TOWN OF CHAPIN
Architectural Review Board
Regular Meeting
Council Chambers, Chapin Town Hall
October 1, 2025
6:00 PM

To: Architectural Review Board
From: R. Radtke, Planning & Zoning Manager
Date: September 24, 2025
Re: **Carolina Wings** –Wade Bozeman / Commercial Sub-division

To: Architectural Review Board
From: R. Radtke, Planning & Zoning Manager
Date: September 24,, 2025
Re: Express Oil – Commercial Sub-division

SITE PLAN

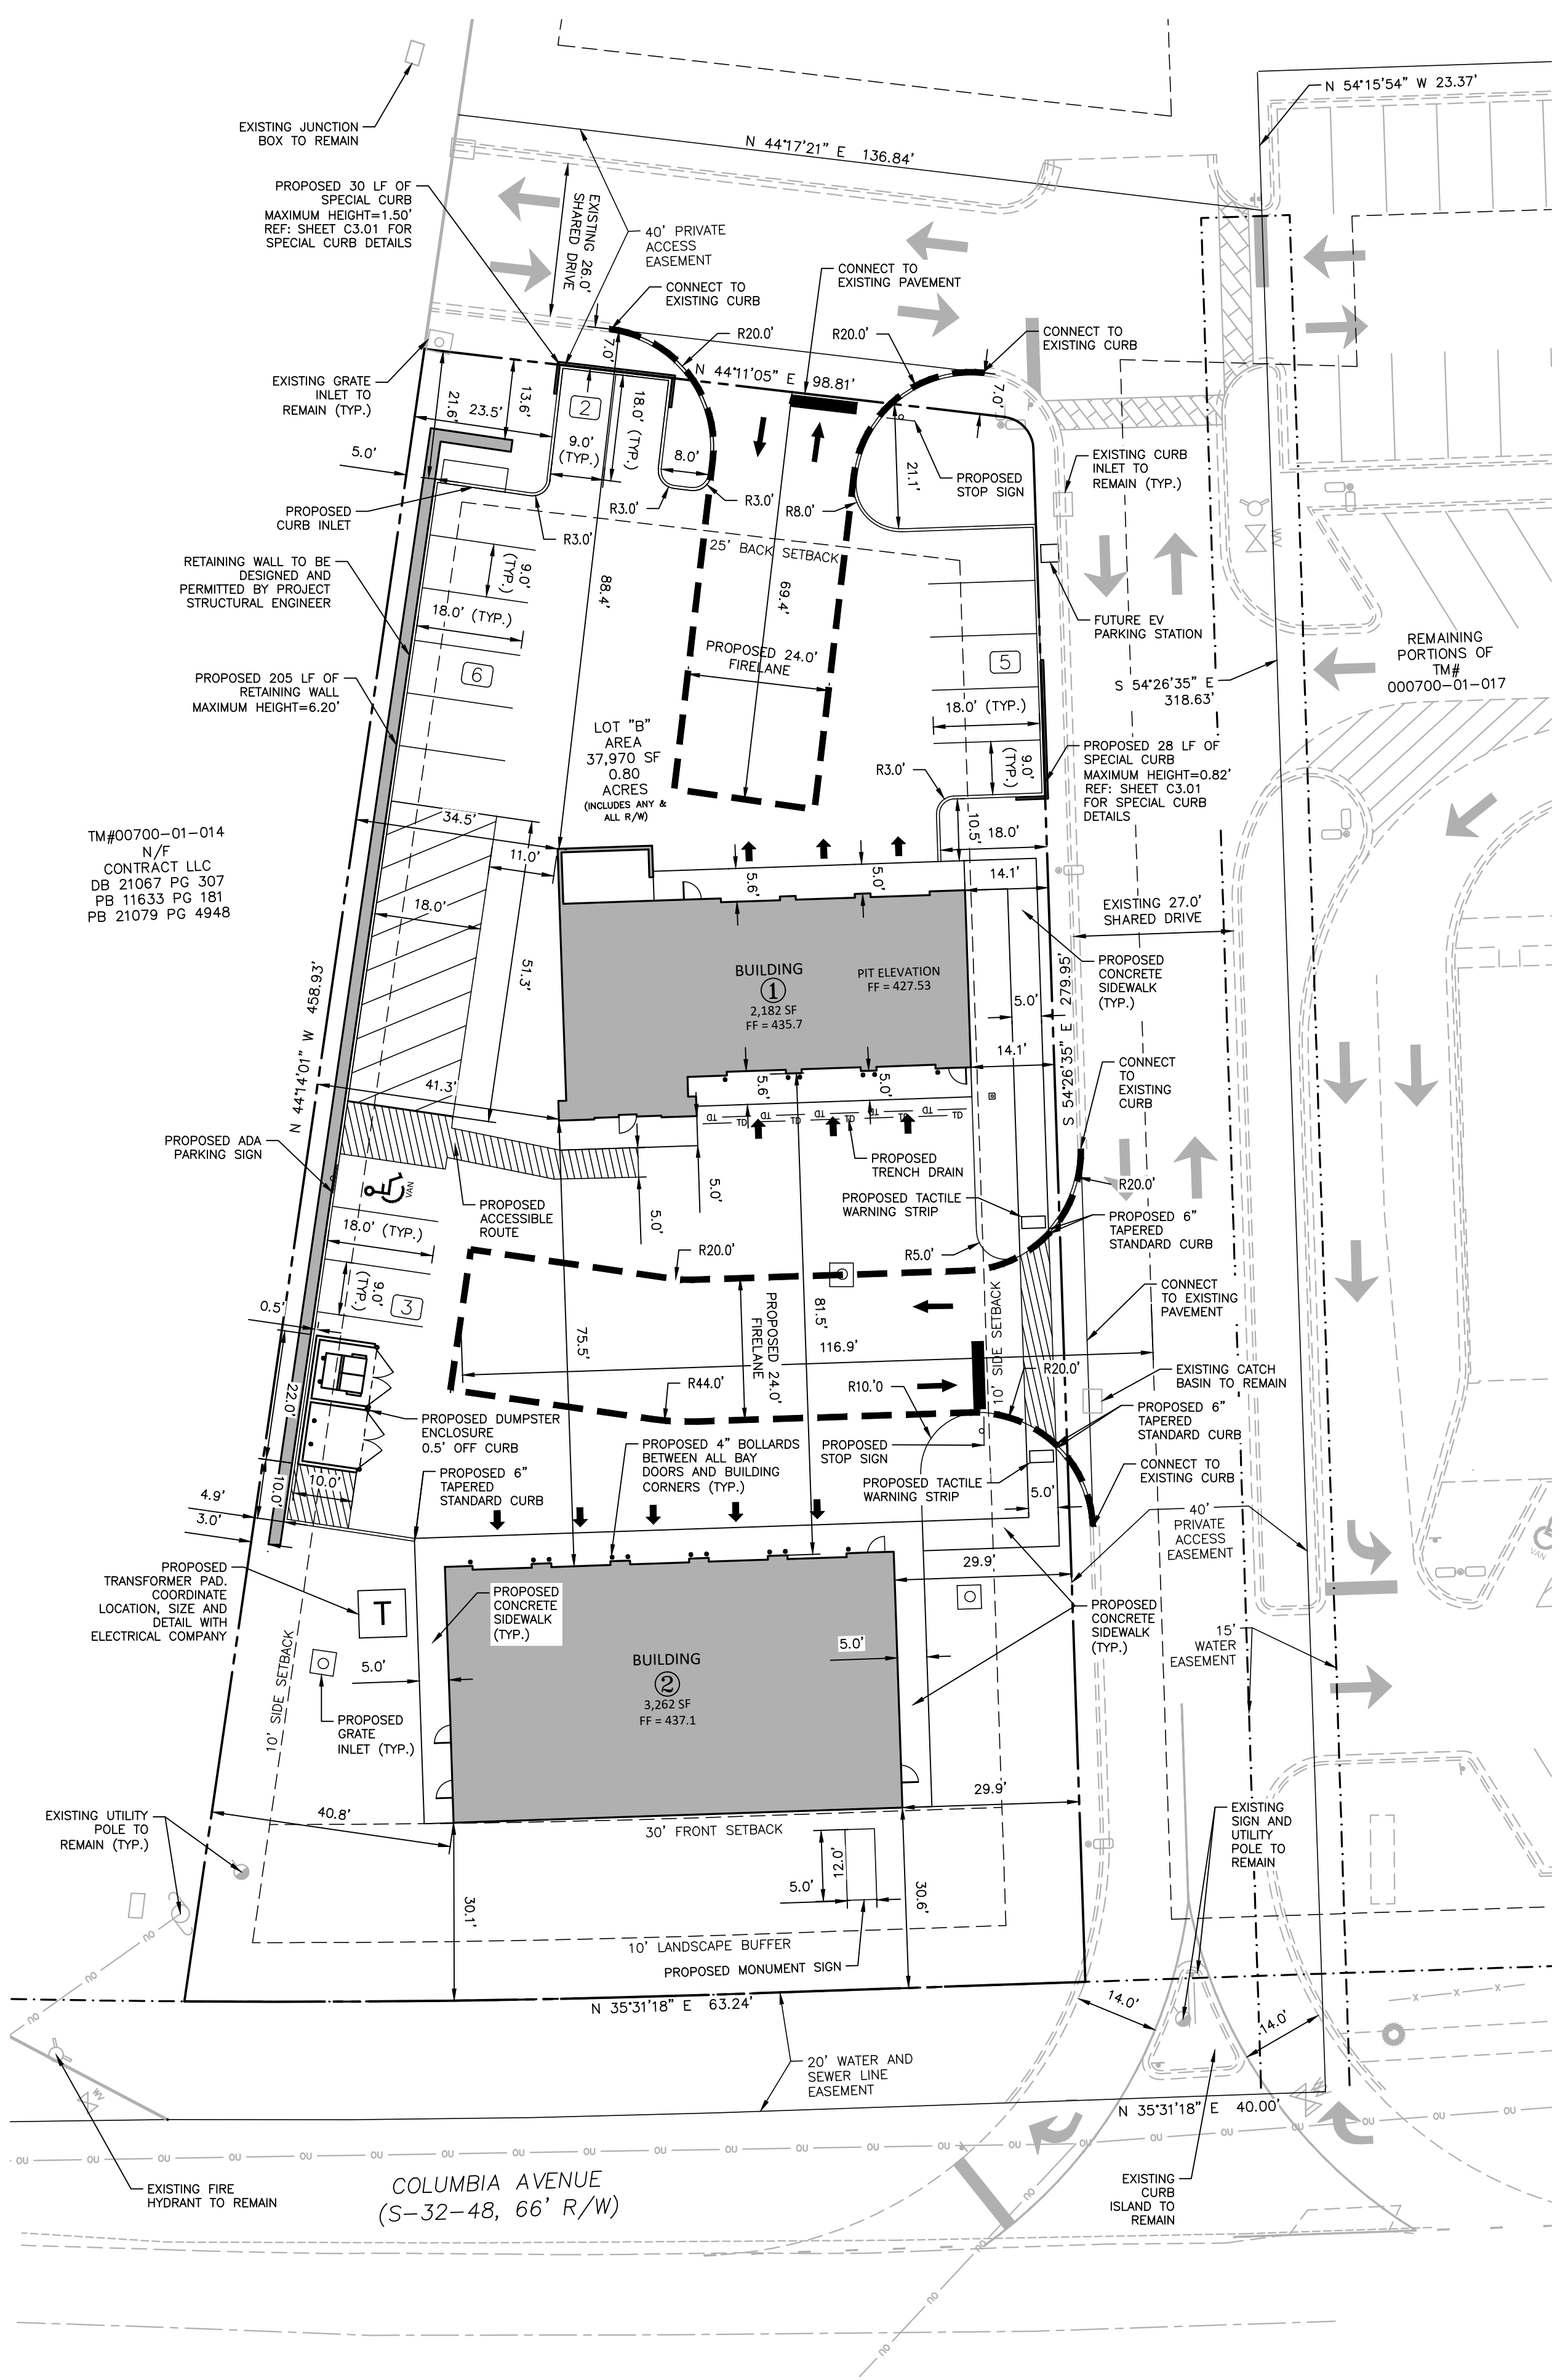
Total size of the building is 2957 Sq. Ft. / 1 space per 150 Sf = 24 Spaces. Applicant has planned for 16 spaces. **Parking requirements are short of minimum required.**

- Exterior color of building have been changed. Brick colors – New Ashbury, Stone color - Sedona, Clay face brick – Whitestone. Overhead doors –Brown. **In Compliance**
- Remove glass & change the color of metal slats- garage bay doors. **In Compliance. Changed to brown & added panels to 4.**
- ARB commented; prefer shingled roof instead of the metal roof. **No Change. In Compliance.**
- Lighting plan with spec sheets & Photometrics -provided – **Review by ARB.**
- Parking is short of the 25 spaces required. Currently 16 spaces. **(Table 8.4.1). Recommend written agreement with adjacent property.**

1 Site Plan - Photometrics
1" = 20'-0"

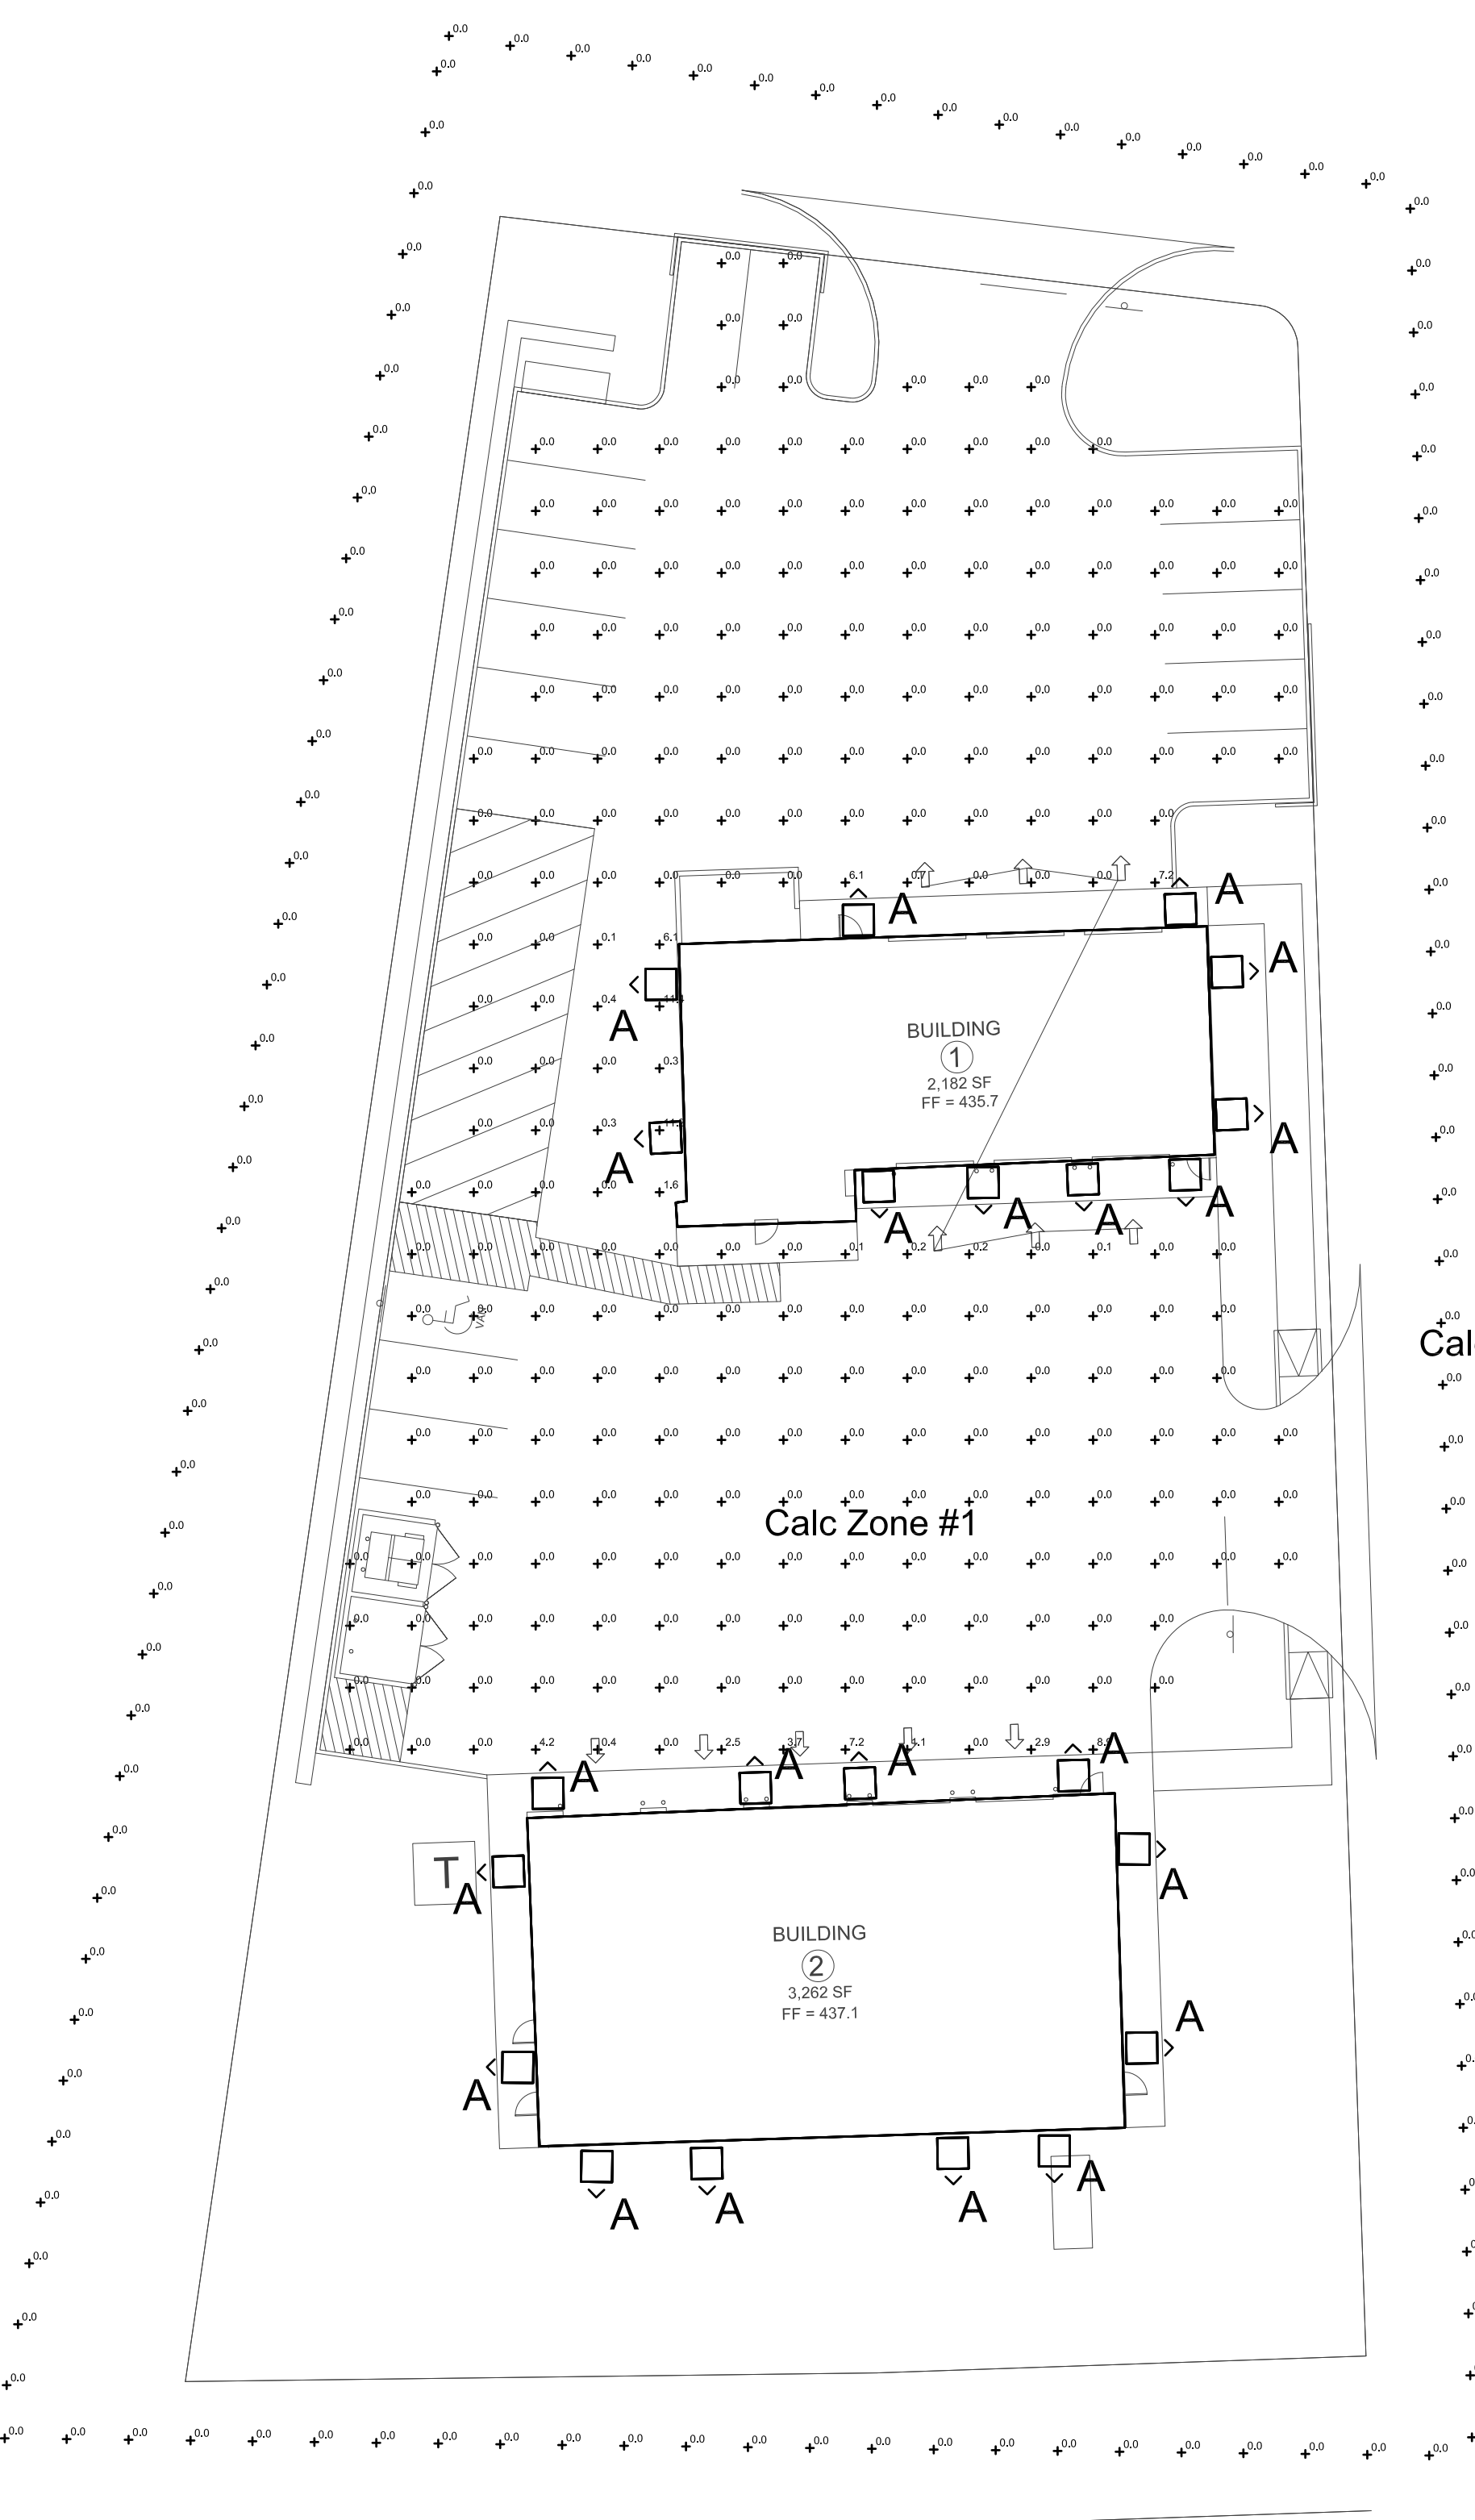
- Exterior color of building that are shown. Brick colors – 1. Cream White, 2. Brown, 3. Accent= Gunstock, 4. Siding Navajo Beige. **6.12.3.C.3. In Compliance**
 - Required tree mitigation would be 11 trees added to CW for replacement. (1 canopy tree per 6000sq ft) 15 trees planned for CW. **In Compliance**
 - Locations of exterior mounted lighting on building- **Review by ARB**
 - Cutsheets on any building mounted exterior lighting. **Review by ARB**
 - Contributions on photometric plan of building mounted exterior lighting – **Review by ARB**
1. **Building mounted lights are not indicated on (included in) photometric plan. Locations and contributions need to be included on photometric plan for all exterior lighting.**
 2. **Photometric plan does not include calculation zone on sidewalk at back of building.**

1. Exterior Lighting plan.
2. Traffic engineer to provide details to PC on the 29th.
